Application Number P23-01

P23-01 Tractor Trailer Parking-Storage Area

Property Owner: AF Stan Real Estate LLC
Applicant: Jay Bruckner
Location: 5854 West Smith Road
(Parcel Number 53-31C-02-007)
Zoning: I-1 (Industrial)
Request: Site Plan and Conditional Zoning Certificate approval for a tractor trailer parking and storage area

5854 W. SMITH RD.
TRUCK PARKING LOT

DRIVE WAY ARRANGEMENT
 SCALE: 1"=40"
 A F STAN REAL ESTATE LLC.
 P.P. #053-31C-02-007
 DUAL JURISDICTION LOT #9078
 5854 WEST SMITH RD.
 4.1414 ACRES (RECORD)
 4.1387 ACRES (SURVEYED)

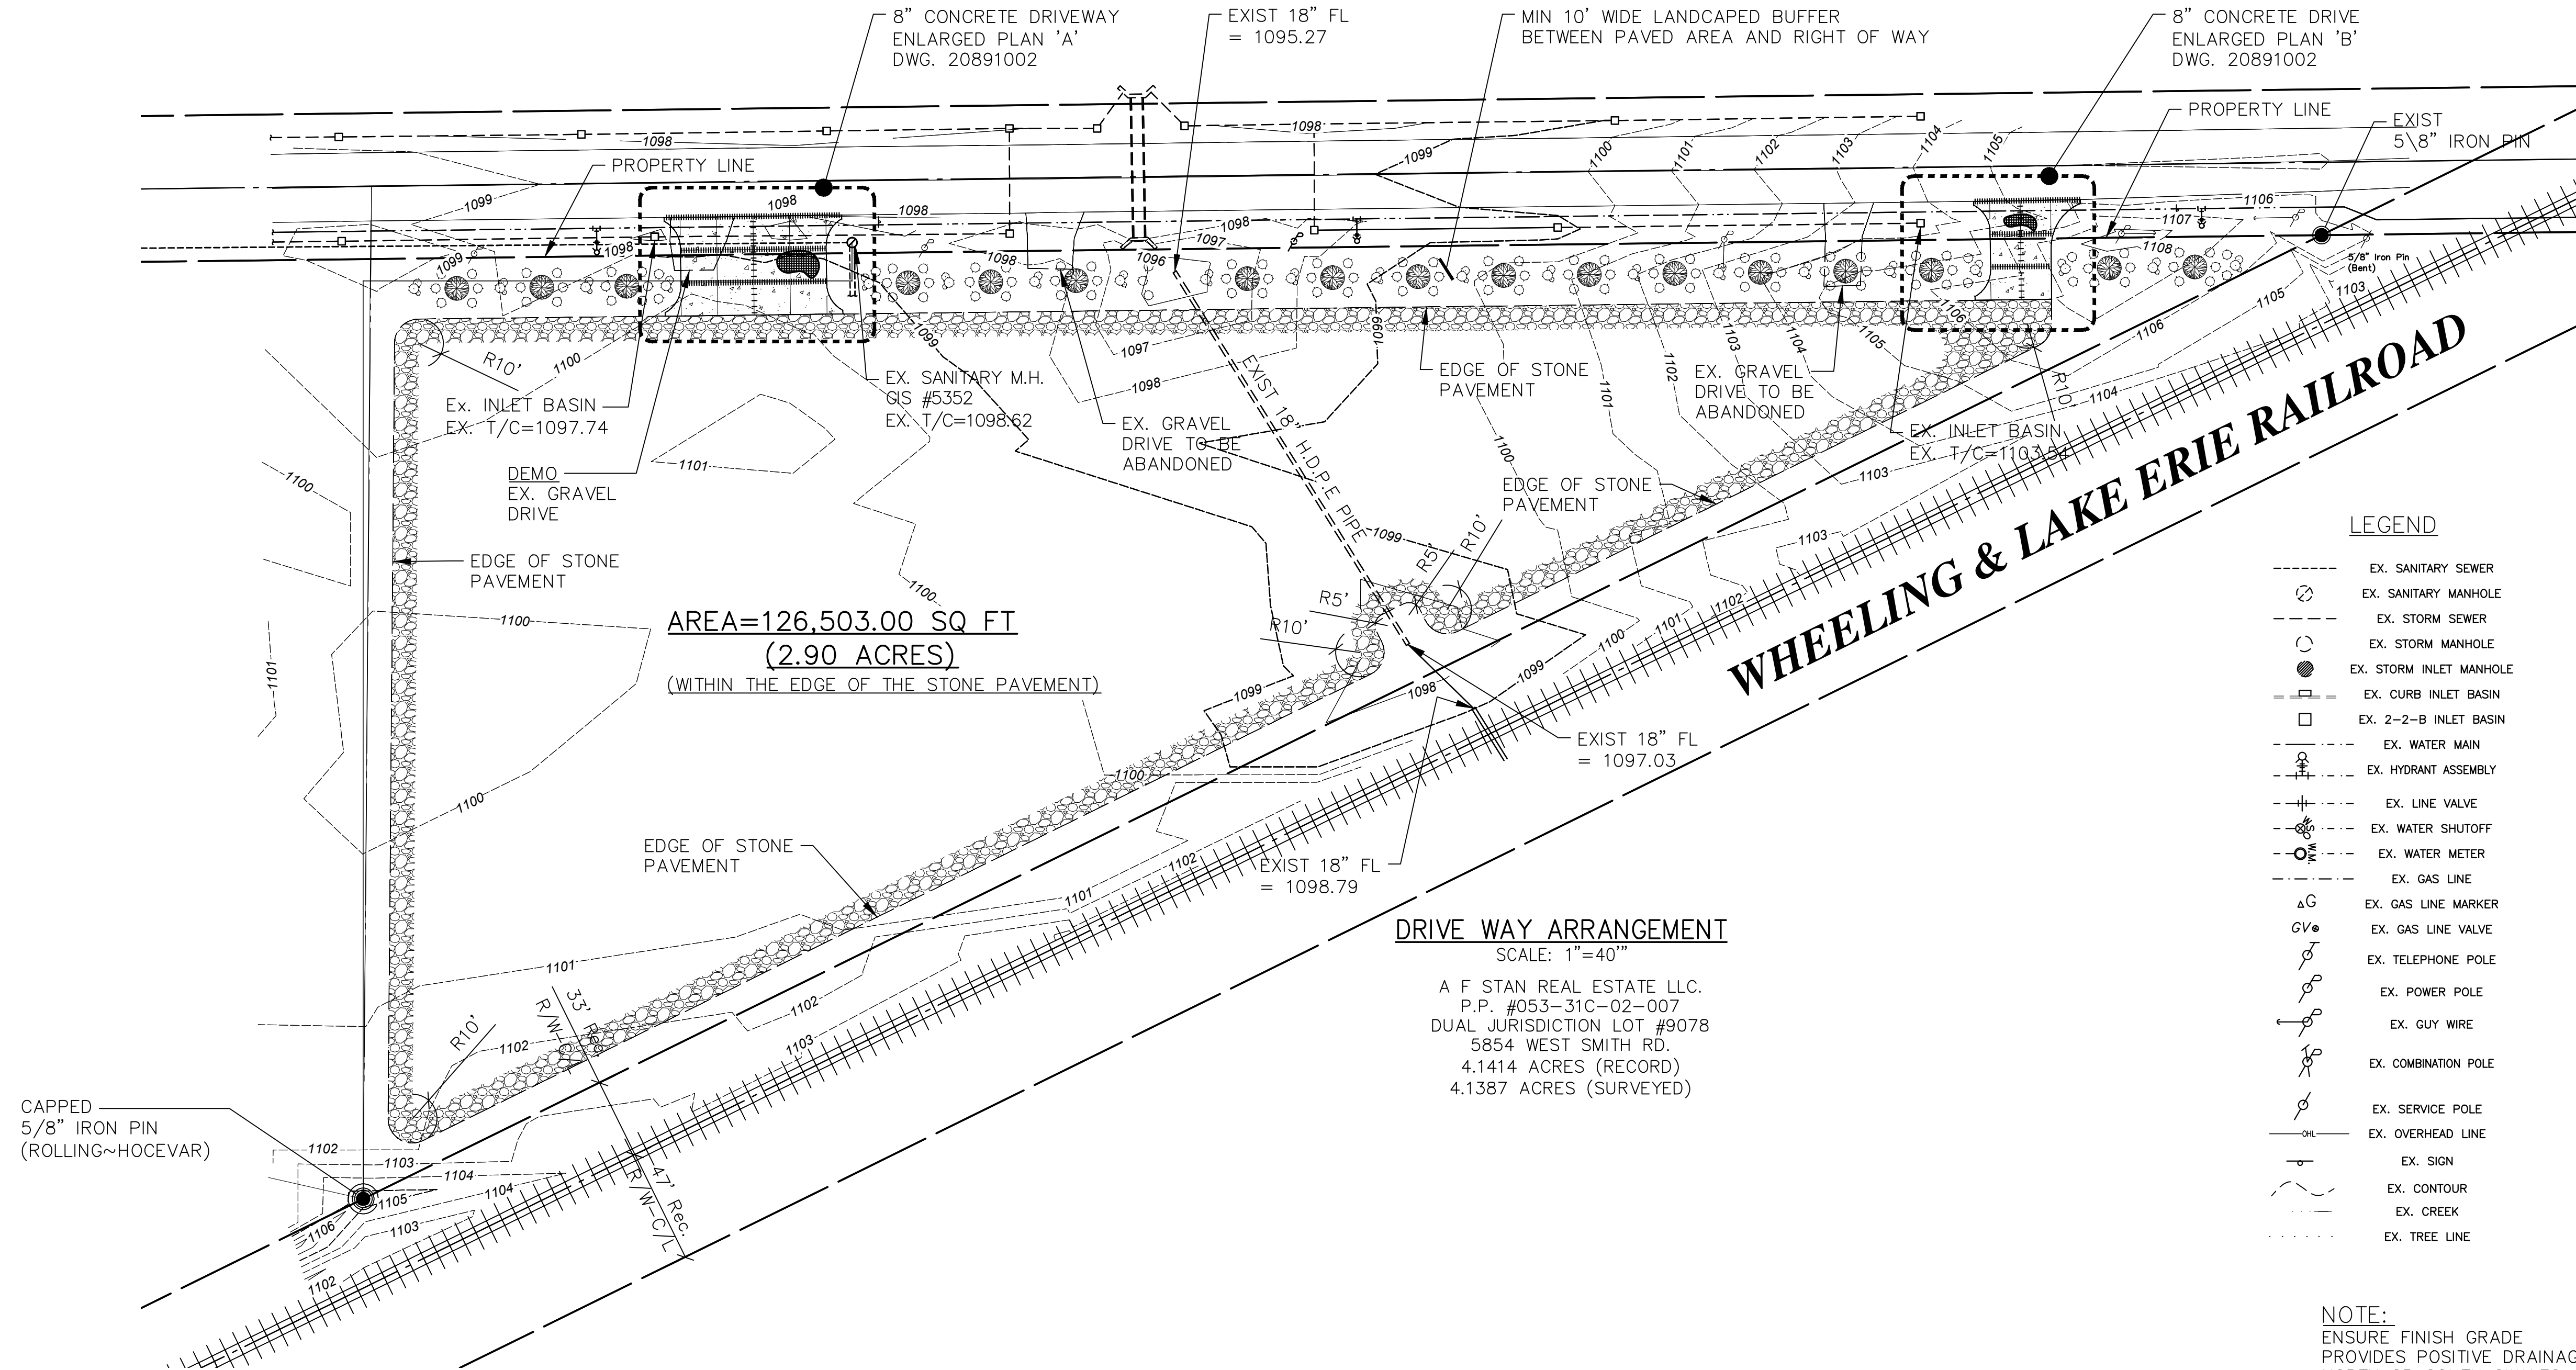
Access and Circulation – The proposed site includes two access drives with concrete aprons off West Smith Road. Section 114510(e) requires that access drives must be between 24 ft. to 60 ft. wide at the right-of-way and a maximum of 120 ft. wide at the curb line. Access drives have been revised to meet the required widths.

Further noted is a requirement for driveway aprons to be constructed with concrete and compliant with access driveway width requirements. Plans have been revised to incorporate concrete drive aprons with appropriate widths.

3. The driveway aprons must be concrete.
4. Per City Codified Ordinances Section 1145.10 DRIVEWAYS TO PARKING AREAS the maximum driveway width at the right of way in an industrial area is 60 feet. The plans show a width of 65 feet.

LIGHTING ARRANGEMENT

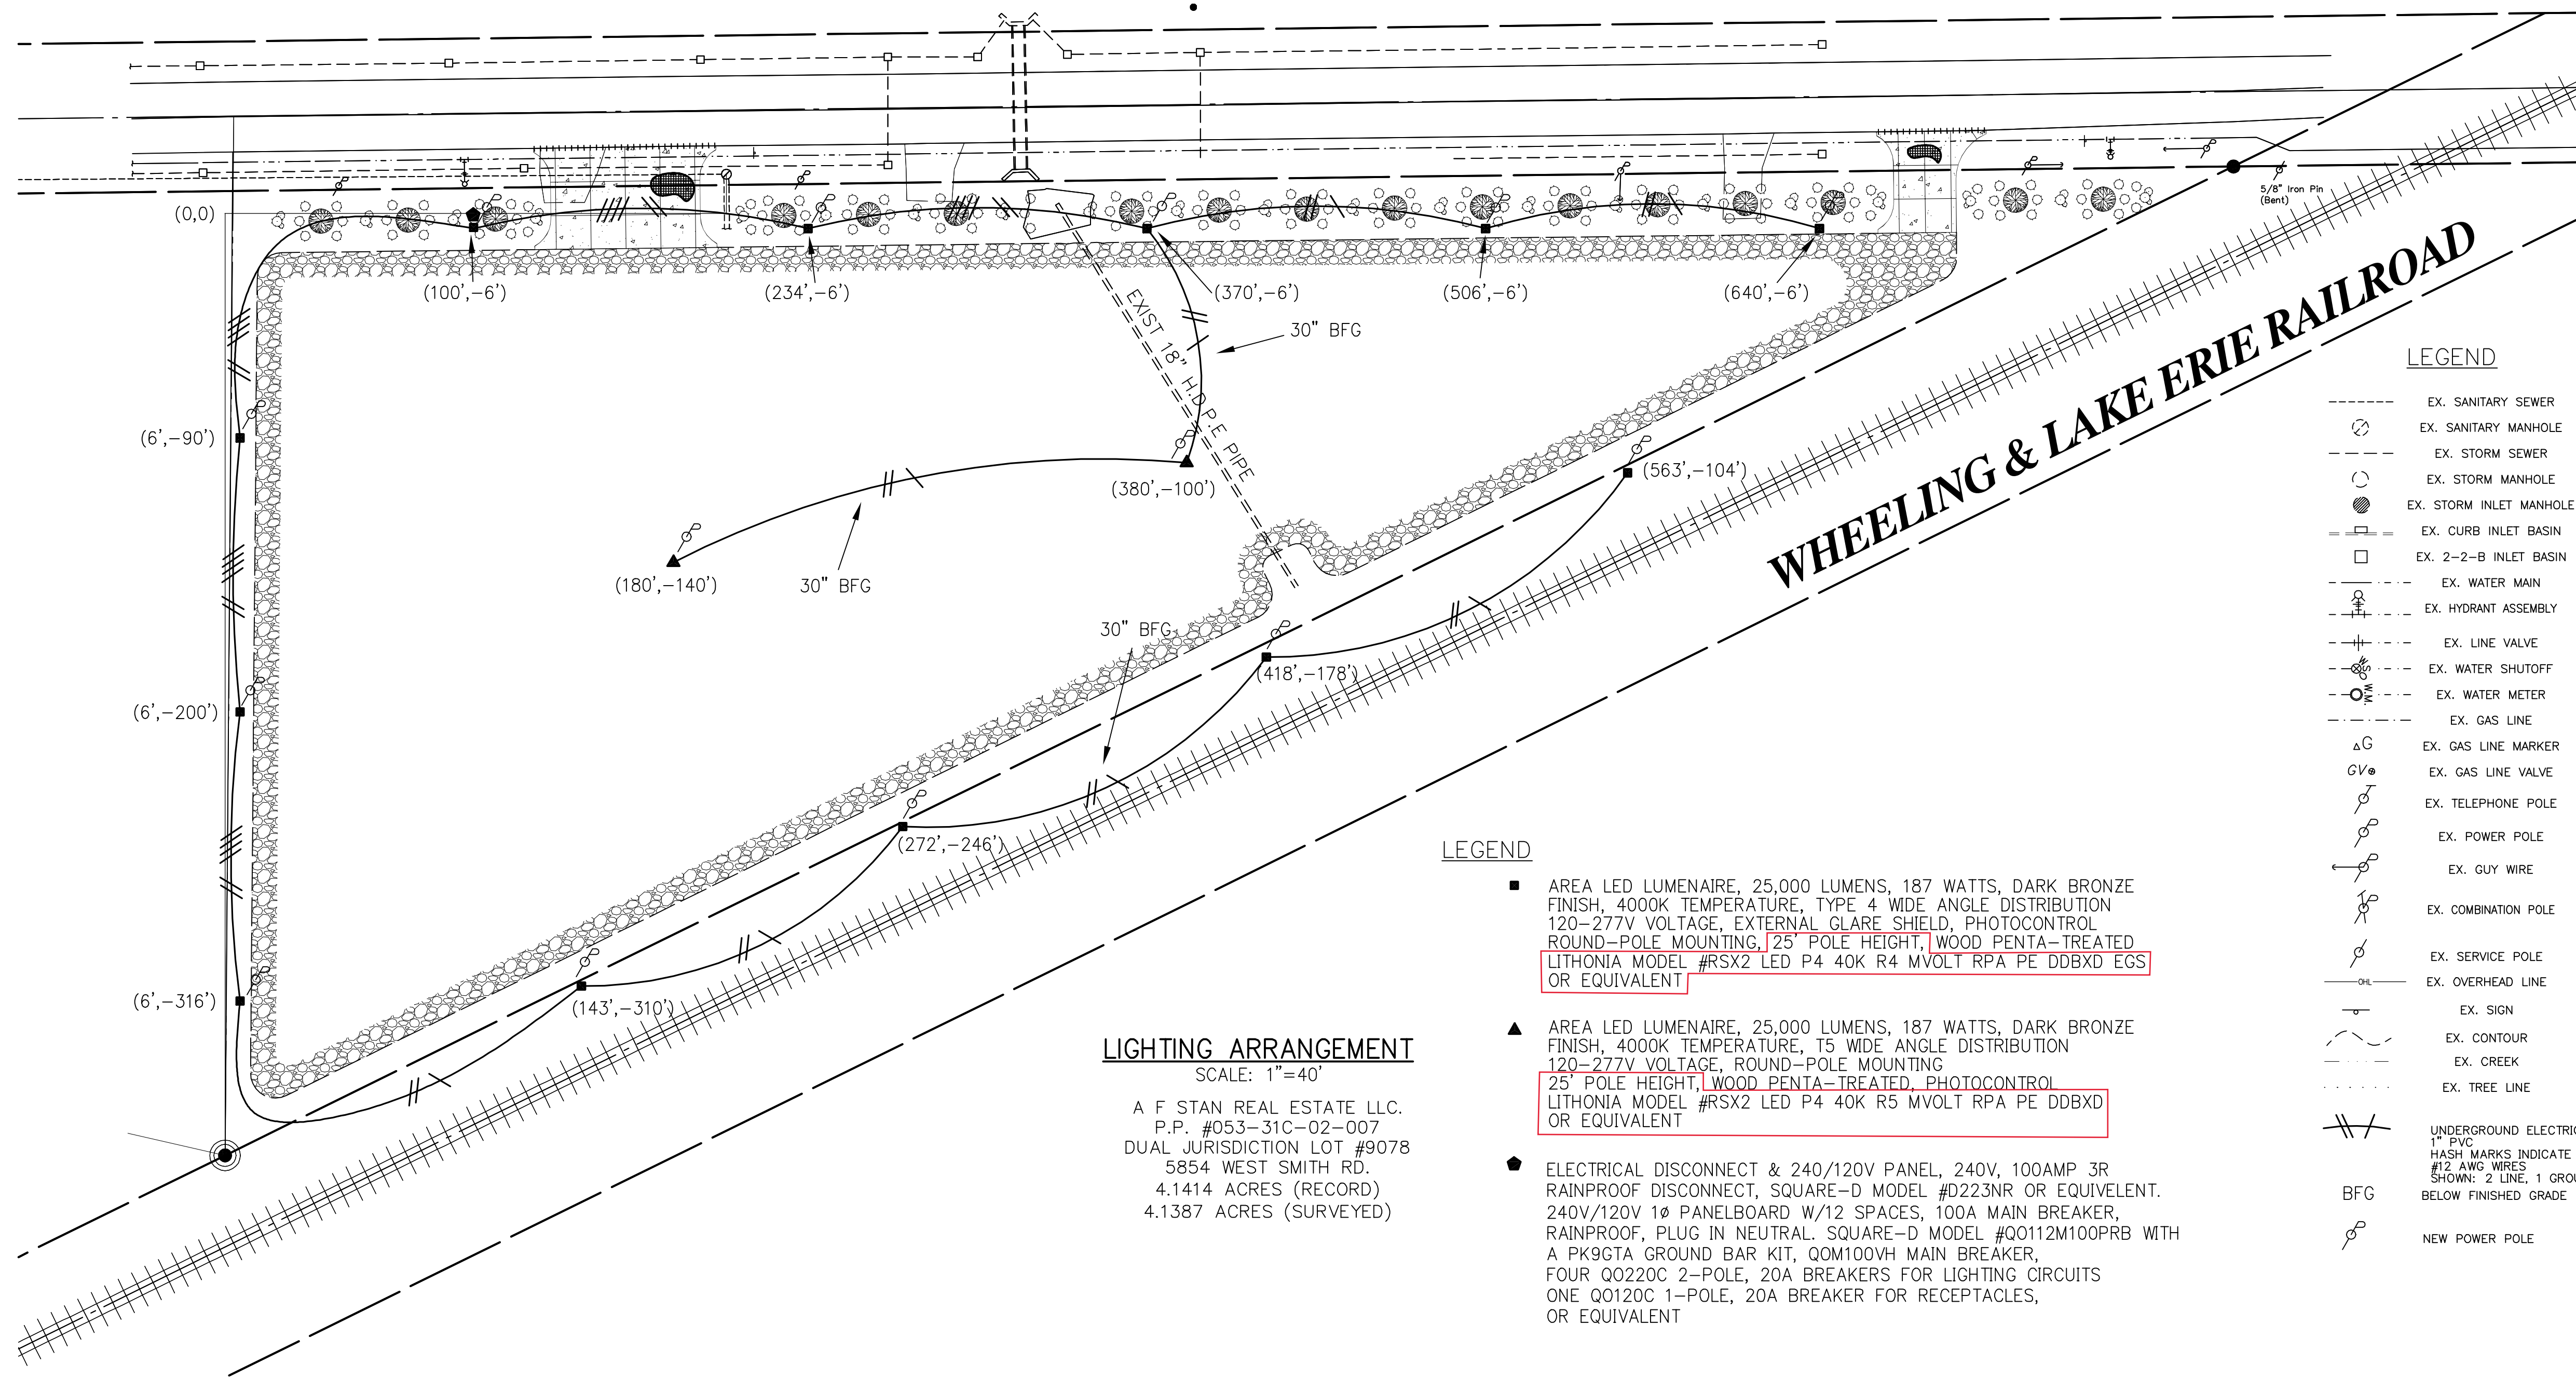
Section 1145.09 requires lighting to have a maximum height of 25 ft. and incorporate a full cut-off fixture that shines straight down. On the "Lighting Arrangement" page of the plans, lighting has been noted as 25 ft. in height with a Lithonia Model #RSX2 fixture, which appears to be a full cut-off fixture.
